UNITED STATES PATENT AND TRADEMARK OFFICE

| APPLICATION NO. | FILING DATE | FIRST NAMED INVENTOR | ATTORNEY DOCKET NO. | CONFIRMATION NO. |
|---|-------------|----------------------|---------------------|------------------|
| 10/658,769 | 09/10/2003 | Thomas J. Wood | IMED-0010-US | 4079 |

Office Action Summary

DETAILED ACTION

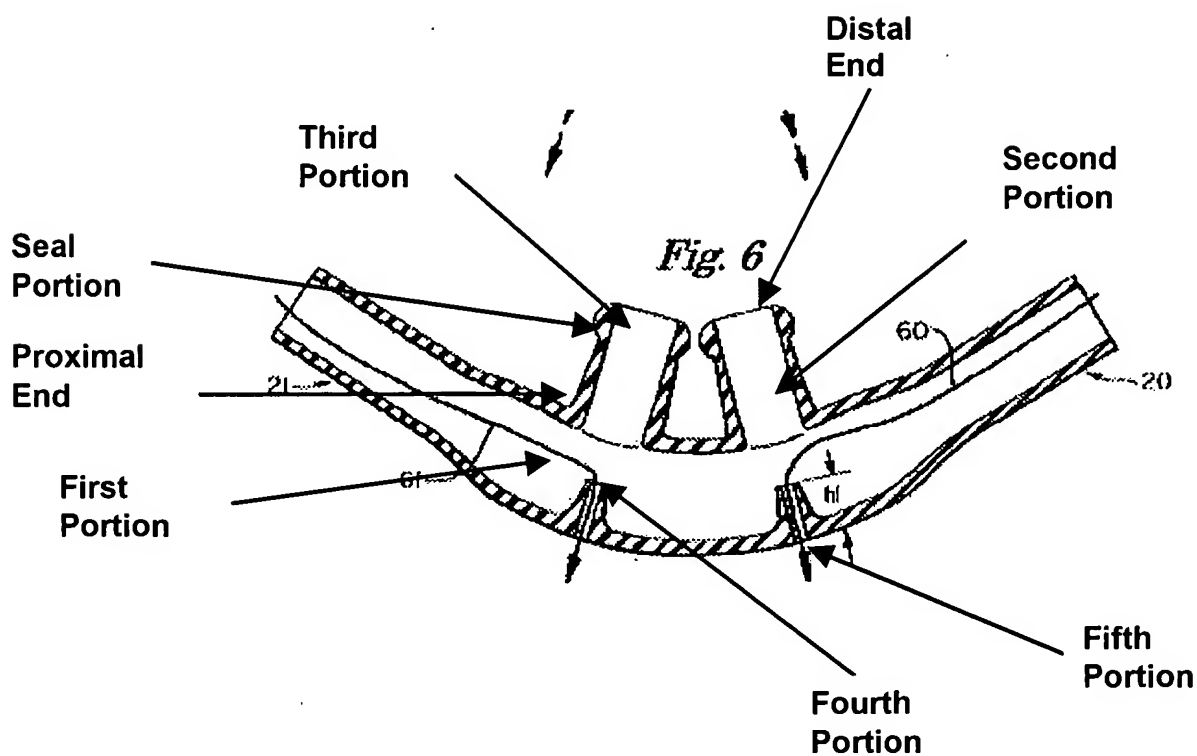
- a cannula (Figs. 3-7)
- with at least one nasal insert (12, 13) and at least one exhaust port (16, 17);
the cannula forming a first portion of an input gas flow passage (see illustration of Fig. 4 below) to supply the ventilation gas to the user;
- the first portion of an input gas flow passage is substantially axially aligned with the at least one nasal insert (See illustration of Fig. 6 below, the first portion is **substantially** axially aligned with at least one nasal insert)
- the at least one nasal insert forming second and third portions of the input gas flow passage from the nasal cannula to a distal end of the nasal insert; and
(see illustration of Fig. 6 below); and
- a seal portion (see illustration of Fig. 6 below) adapted to engage at least a portion of the nares, the seal portion being provided on the distal end of the at least one nasal insert;

Applicant's arguments filed 3/14/05 have been fully considered but they are not persuasive. Applicant argues that the first portion of an input gas flow passage of Strickland is not substantially axially aligned with at least one nasal insert, the examiner disagrees with this argument inasmuch the specification is not specific on what constitutes substantially axially the first portion of an input gas flow passage of Strickland does meet the claimed limitations, furthermore, applicant has not provided any criticality. With respect to the argument that Strickland does not disclose wherein the first, second, and third portions of the input gas flow passage are disposed at an obtuse angle. The examiner can find no support in the specification for the first, second and third portions at an obtuse angle but rather only the first and second portions. Also applicant fails to explain why such angle is important over any other angle, Strickland has a laminar flow through the nasal cannula regardless of an obtuse angle with respect to the first, second, and third portions. Applicant's arguments with respect to the obtuse angle are not persuasive.
